Visual Resources Review Board Meeting
Tuesday, August 26, 2025 at **6:00 PM**

AGENDA

SHEET:
C6

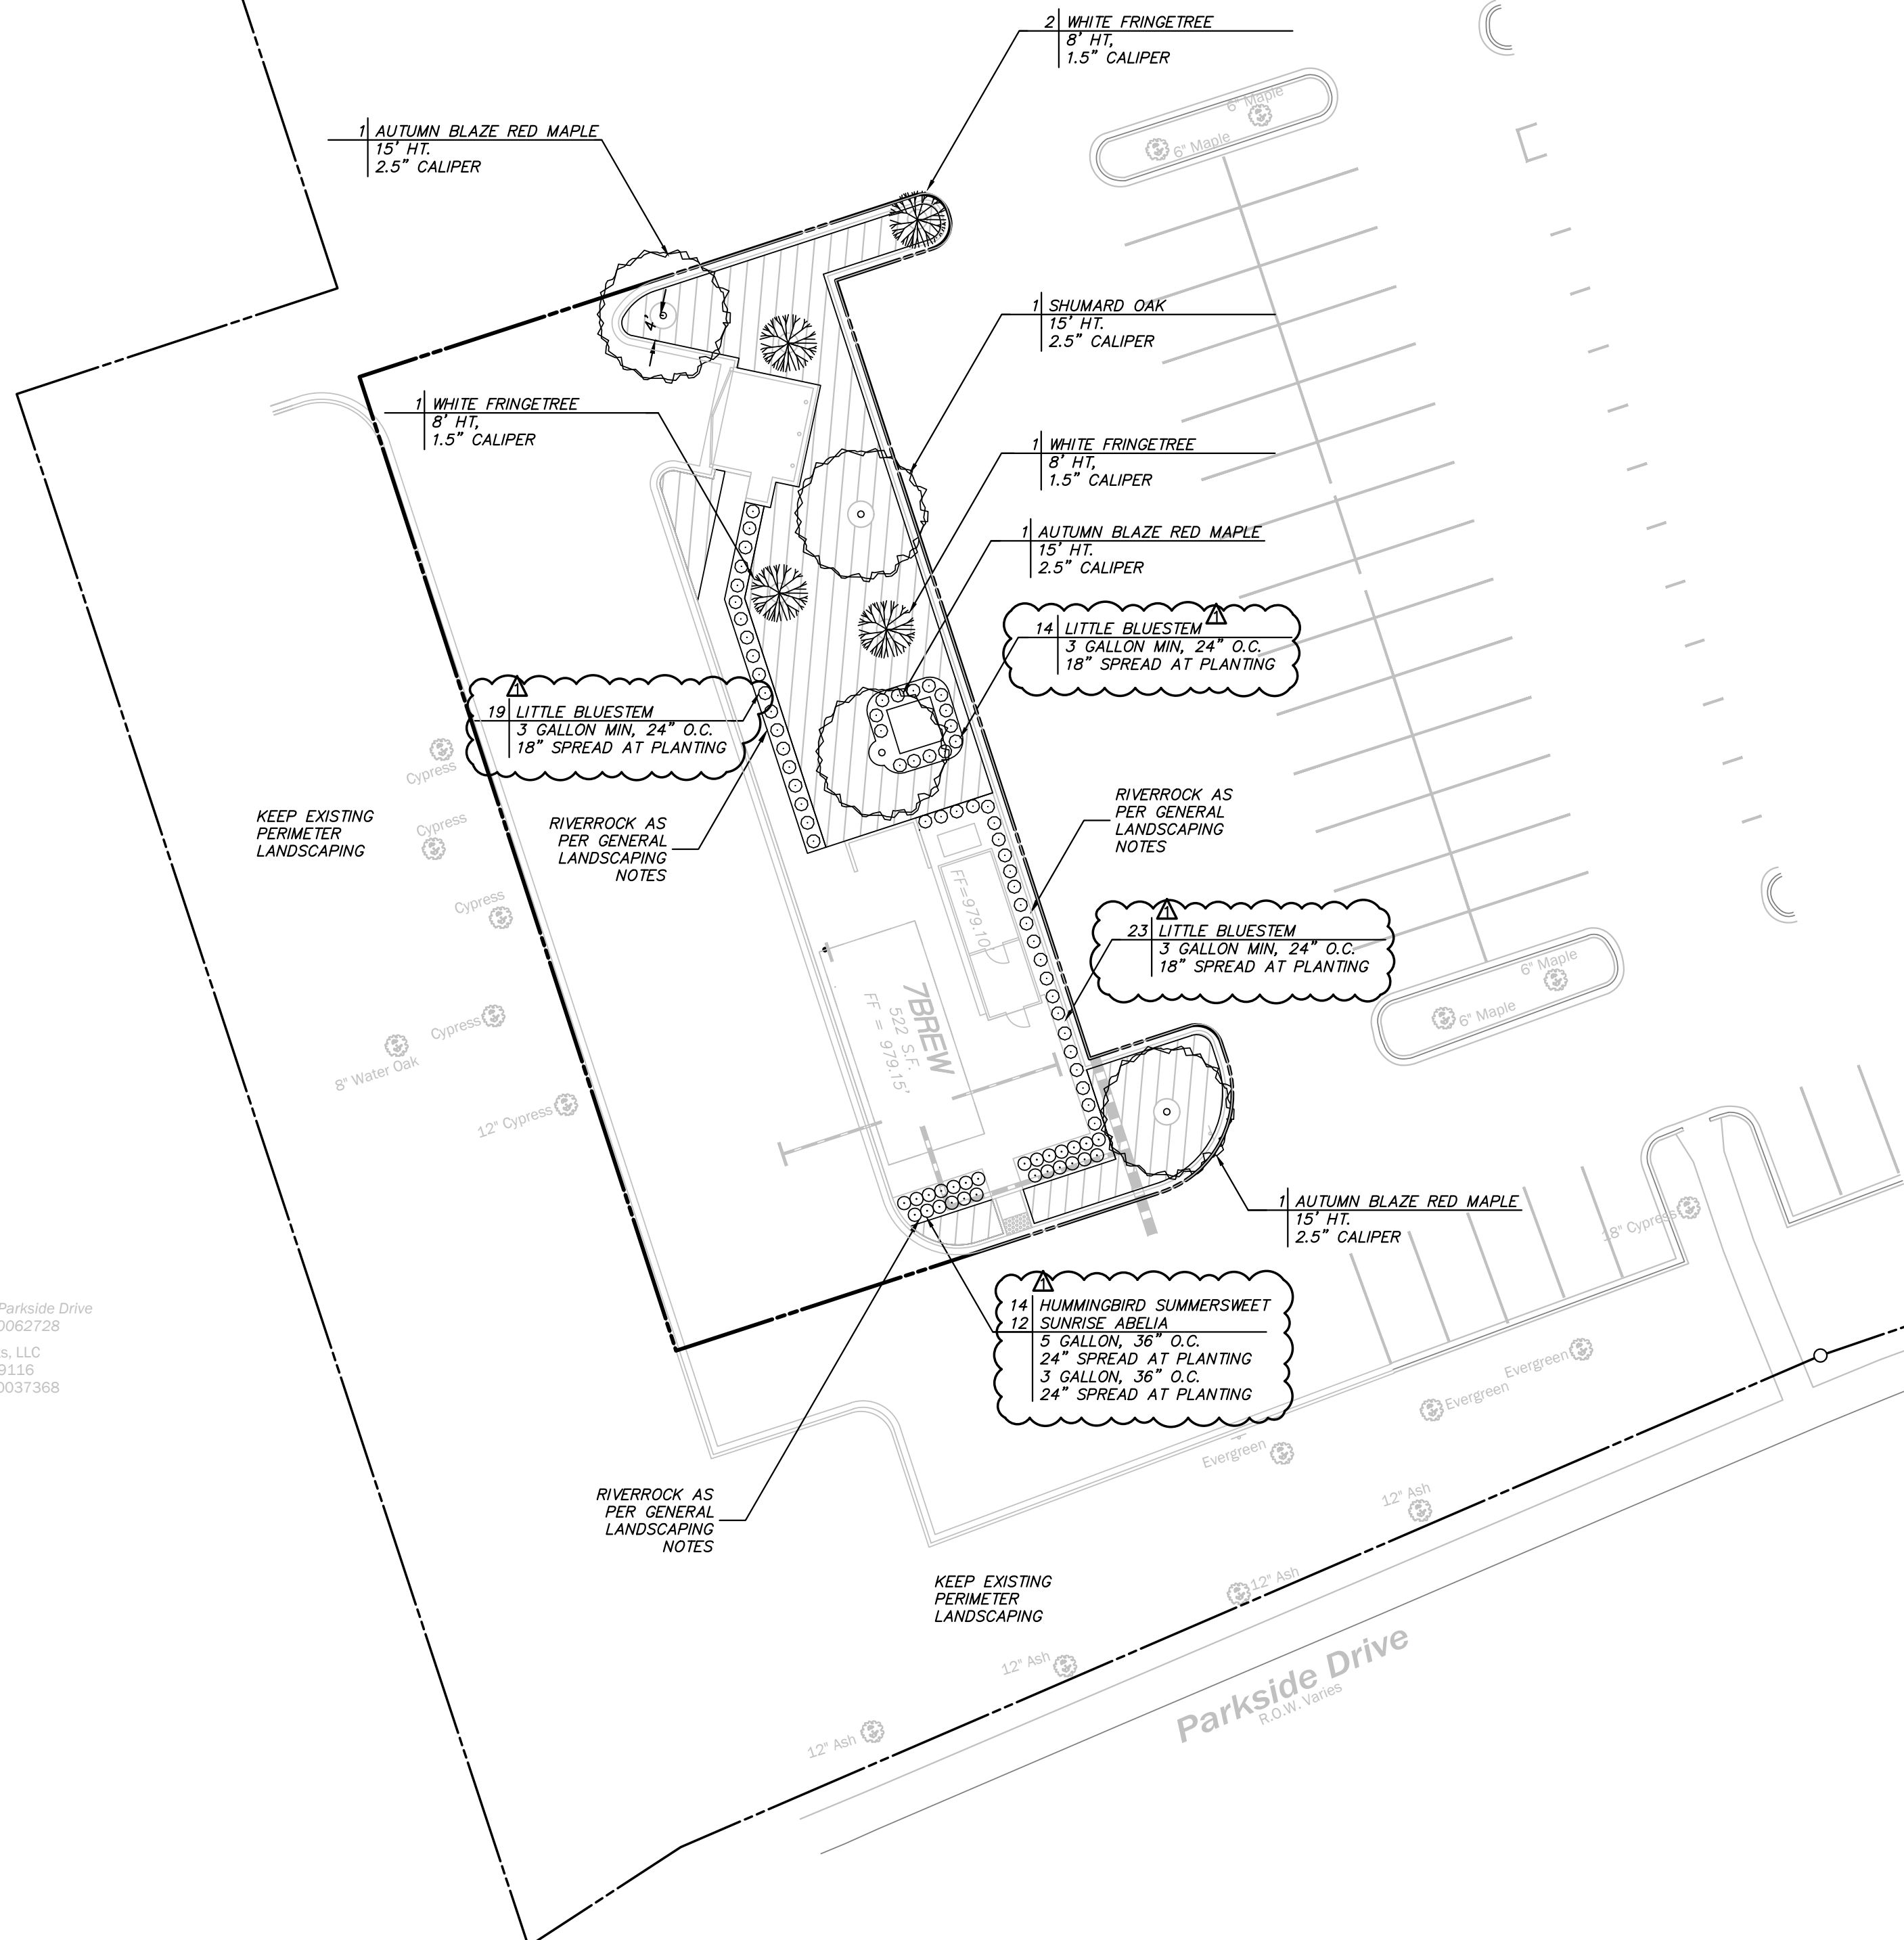
Discussion & Recommendations: In terms of landscaping, this project will create more landscaped area on the site than is in place currently. The project will involve the removal of eight existing trees within the affected area. Those trees will be replaced with the same number of new trees. The applicant has made the requested changes to the landscape plan and the updated version is included in the packet. One item to note for the VRRB's consideration is that the plans show riverstone along with shrubs in the landscaped area being counted for the requirements between the building and the parking lot. This will need to be limited to no more than 25% of this area per the landscape ordinance. With this clarification, the staff recommends approval of the landscape plan.

Proposed Motion: To approve the landscape plan with the adjustment noted regarding the river stone.

L1.1

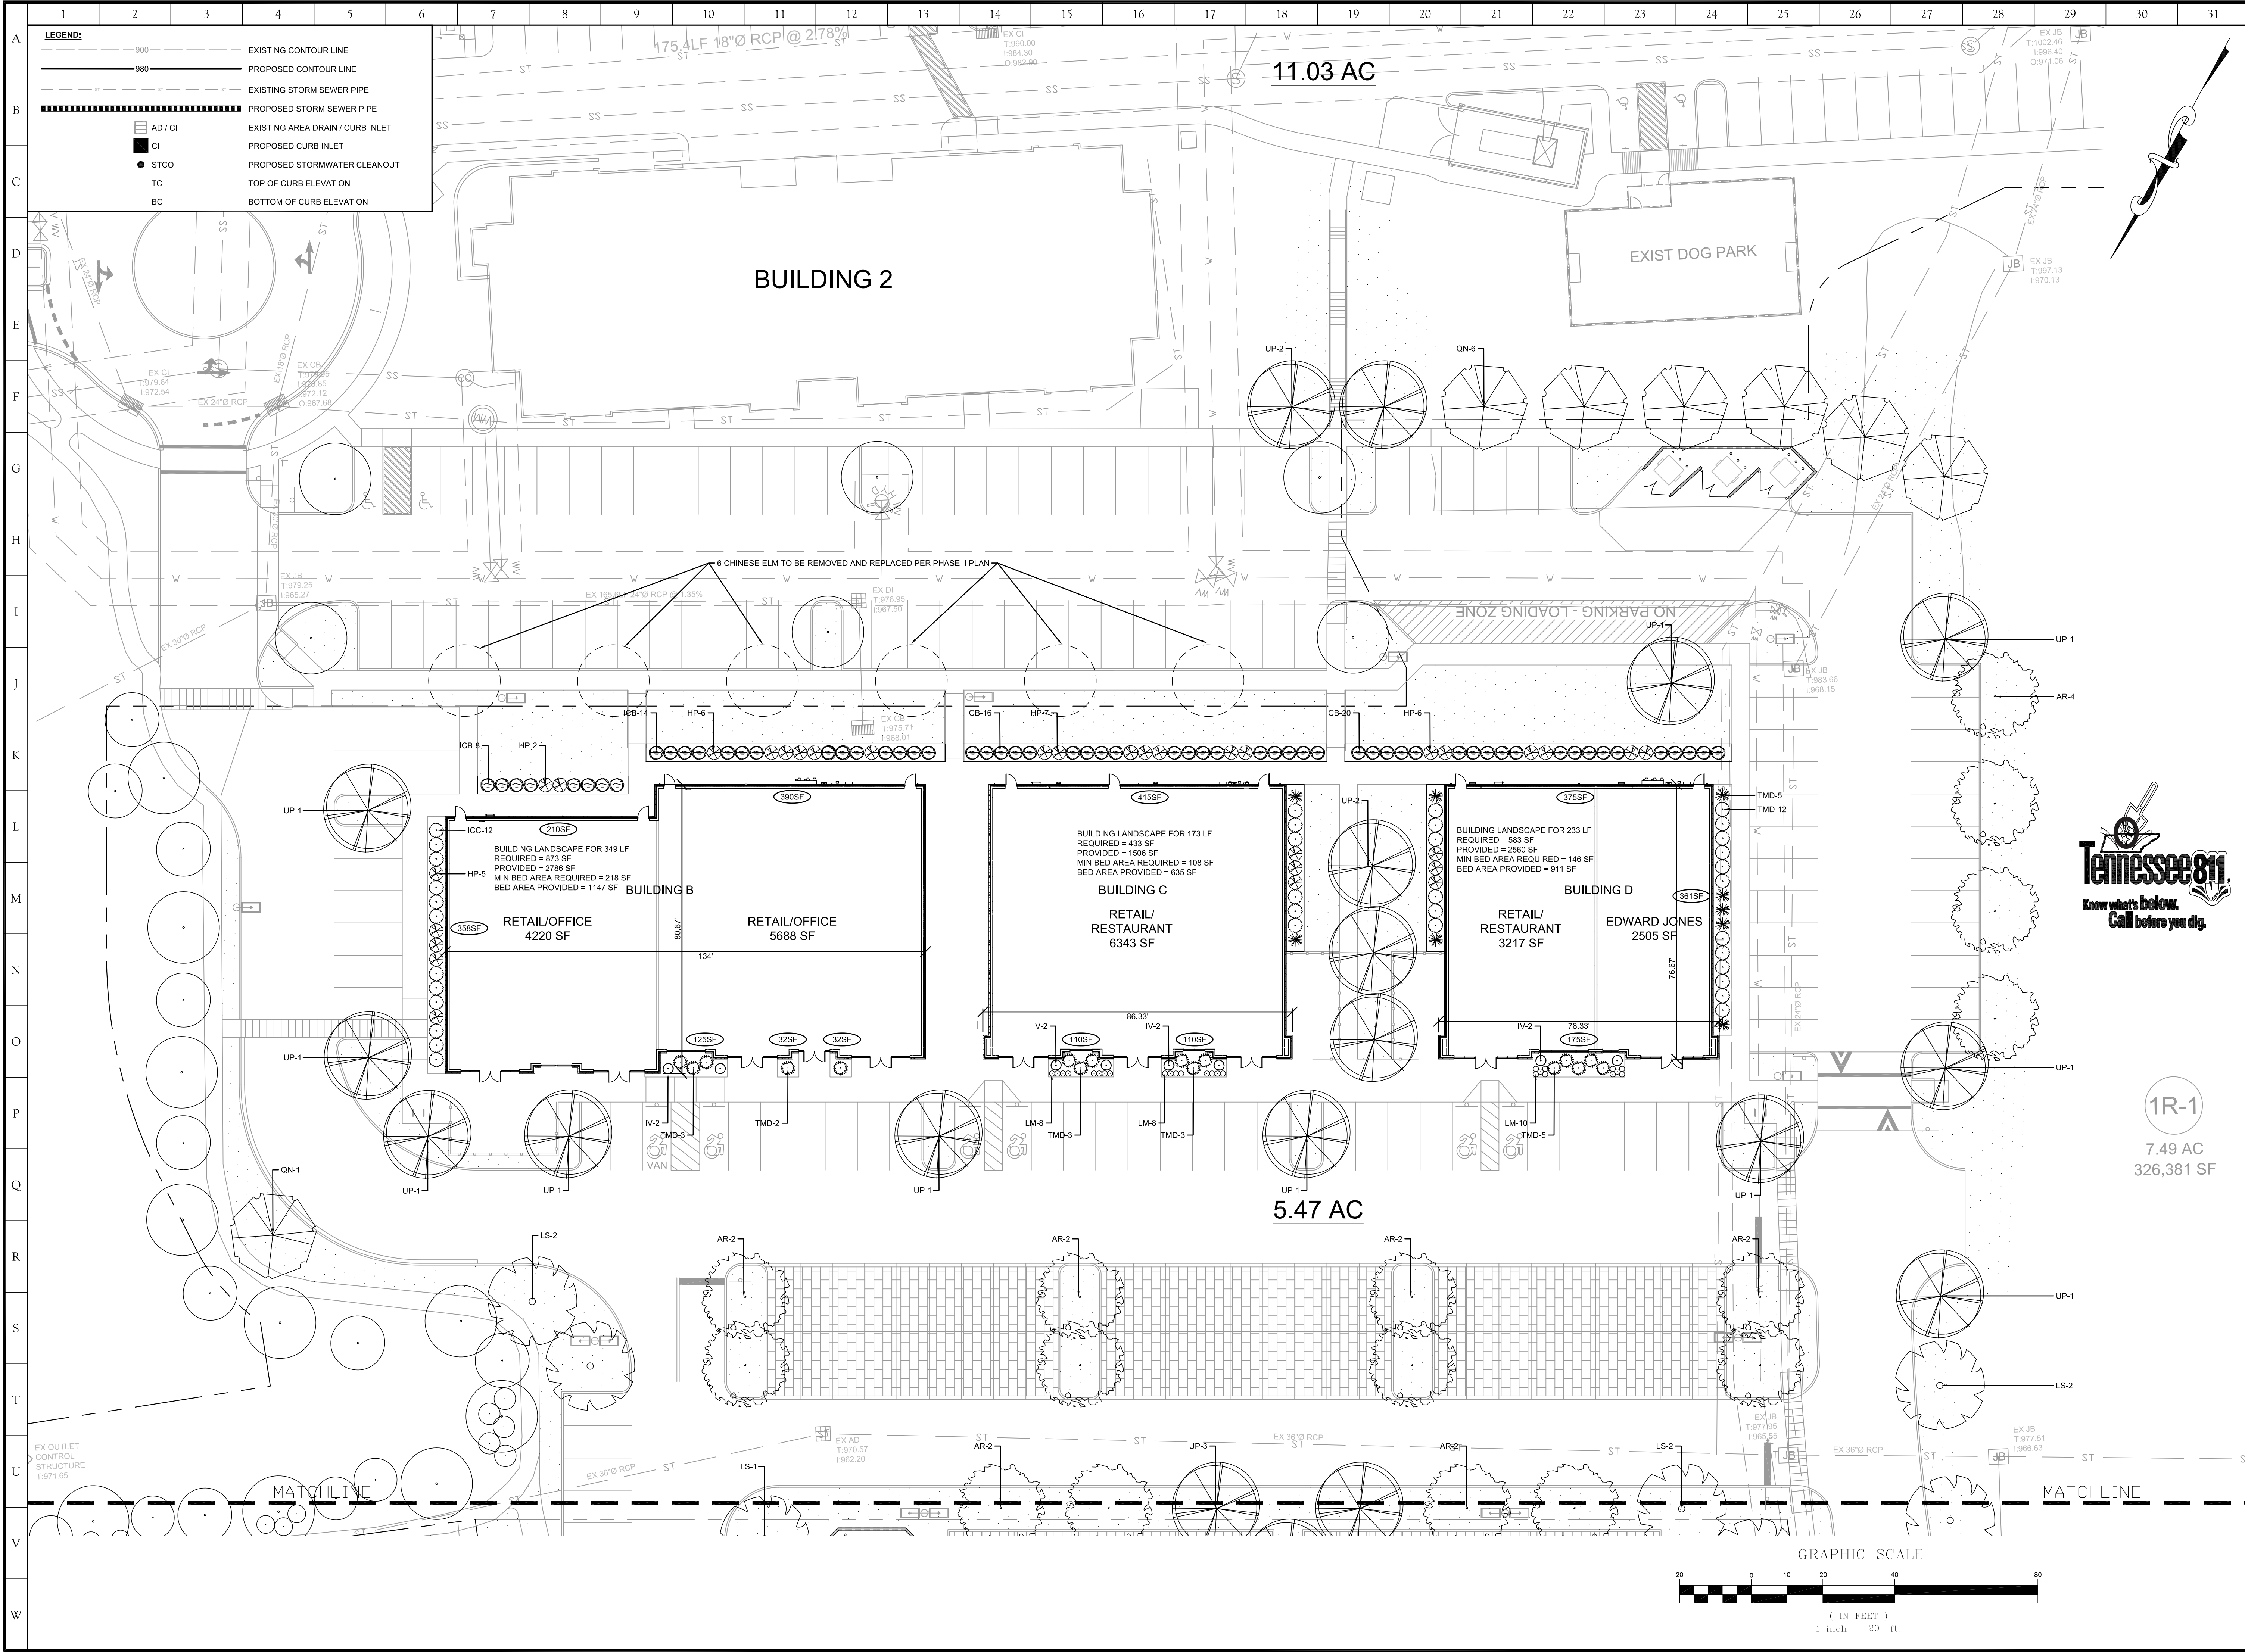
Discussion & Recommendations: This project involves the commercial portion of the Planned Commercial Development that also included the Farragut Junction Apartments that were completed several months ago to the south of the commercial area. Originally, the commercial portion of this project featured a grocery store with a fuel center and two retail/office buildings along Kingston Pike. The concept was amended with the layout that is included in the packet. This phase now includes four smaller-footprint commercial buildings and some modifications to the Little Joe's Pizza site to tie it into this larger project.
